RE: Application for Extension at Denmark Rivermouth Caravan Park

TITLE	SITE PLAN	SCALE	1:200	A-01 DWG No
PROJECT	BUILDING EXTENSIONS - RIVERMOUTH C/PARK	DATE	30/04/2015	
CLIENT	NOEL PHILLIPS	DRAWN	A.G.

TITLE	FLOOR PLAN	SCALE	1:100	A-02 DWG No
PROJECT	BUILDING EXTENSIONS - RIVERMOUTH C/PARK	DATE	24/04/2015	
CLIENT	NOEL PHILLIPS	DRAWN	A.G.

TITLE	ELEVATIONS	SCALE	1:100	A-03 DWG No
PROJECT	BUILDING EXTENSIONS - RIVERMOUTH C/PARK	DATE	30/04/2015	
CLIENT	NOEL PHILLIPS	DRAWN	A.G.

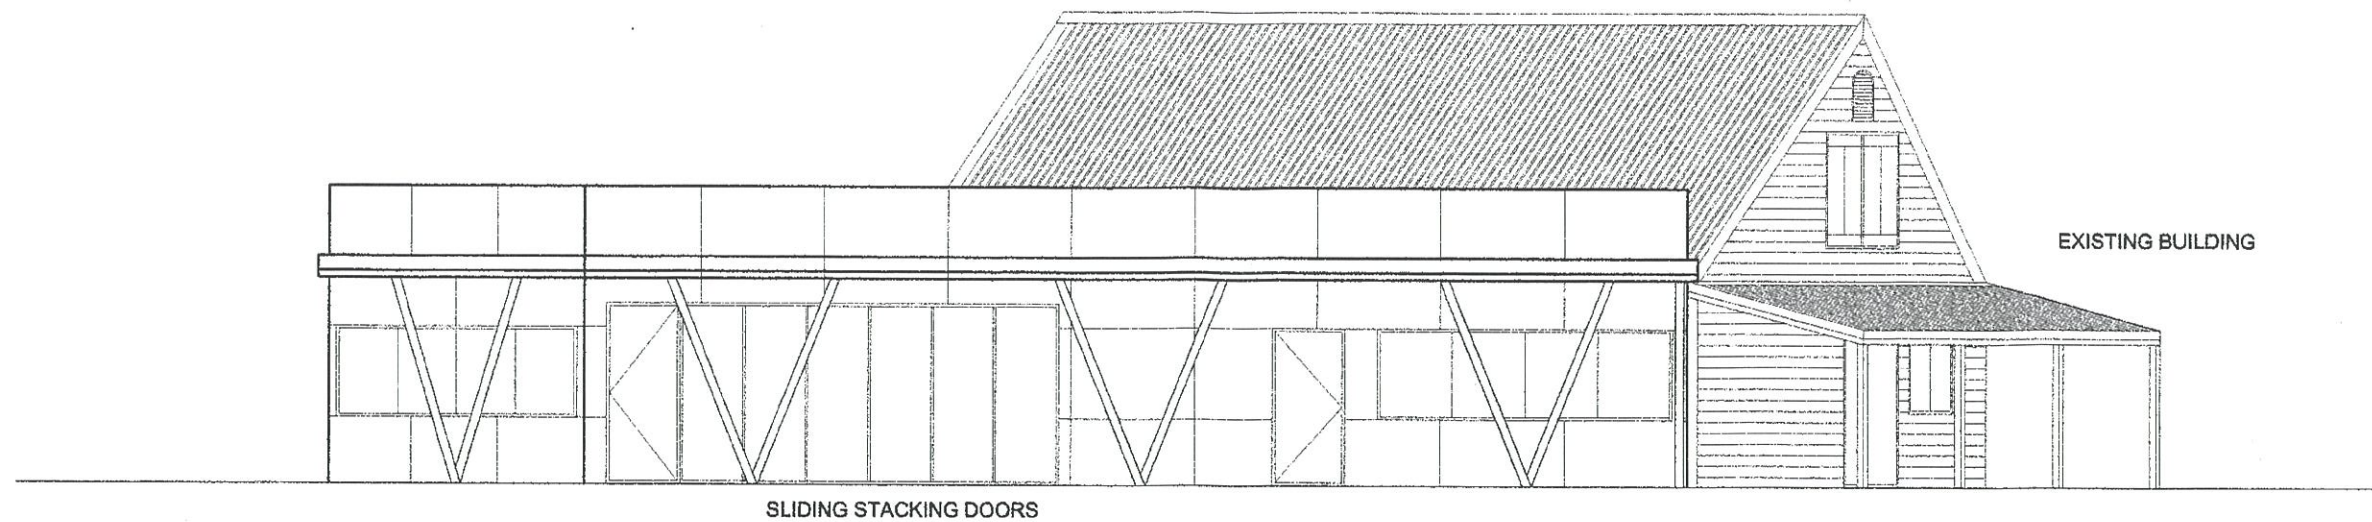
The floor plan submitted (copy attached) makes reference to the existing front verandah on the existing building being removed; noting the arrow is pointing to the verandah that appears to be on the side of the building and is to be retained from the elevations provided – can you please clarify the situation in this regard and if required amend the floor plan accordingly (noting that this has only been requested as amended floorplan(s) is required by Bullet Point 1 so best to just address this issue now).

The veranda that will be required to be removed from the existing building is marked on the plan elevations A-03.
